Subject: AP1000 Response to Request for Additional Information (TR44)

Response to Request for Additional Information on SRP Section TR44

# AP1000 TECHNICAL REPORT REVIEW

RAI Response Number: RAI-TR44-006  
Revision: 4

~~Figure 2-10 Baseplate Deformation Resulting from Fuel Assembly Drop onto Baseplate (2.41-inch Maximum Displacement Directly under Impact Location) – (Superseded by Revision 2)~~

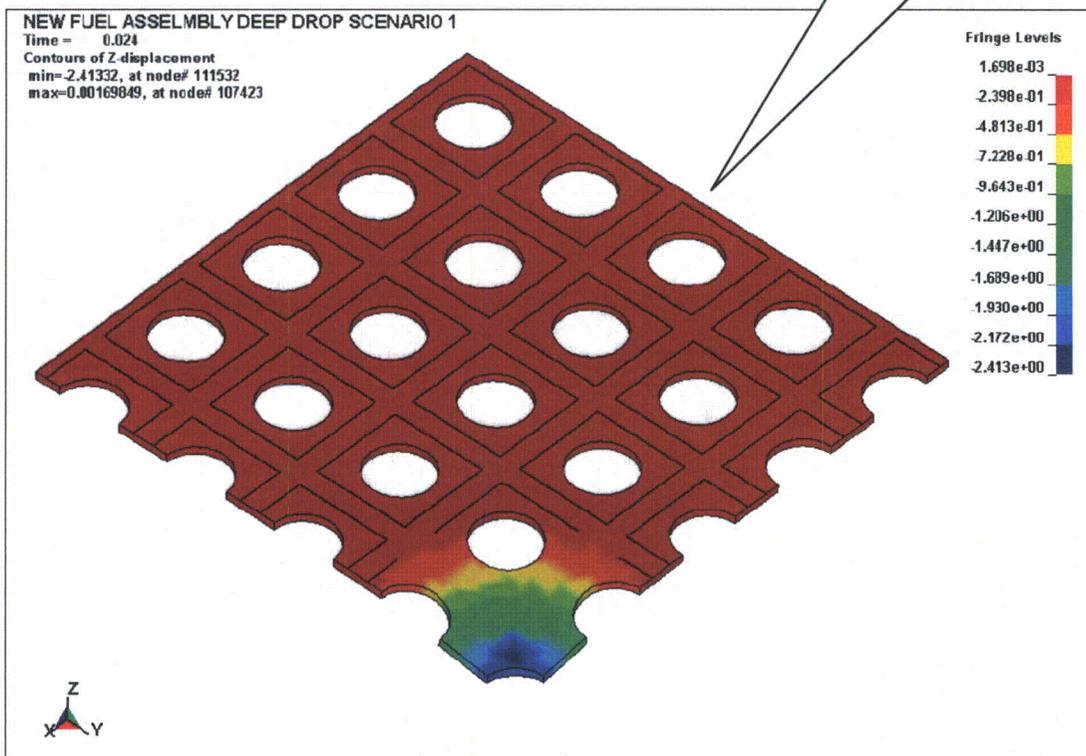
~~Figure 2-10 of TR44 was revised to reflect the updated results of the drop analysis; see the Technical Report Revision section for details.~~

~~Yes – Figure 2-10 was replaced by the following figure:~~

FIGURE DELETED
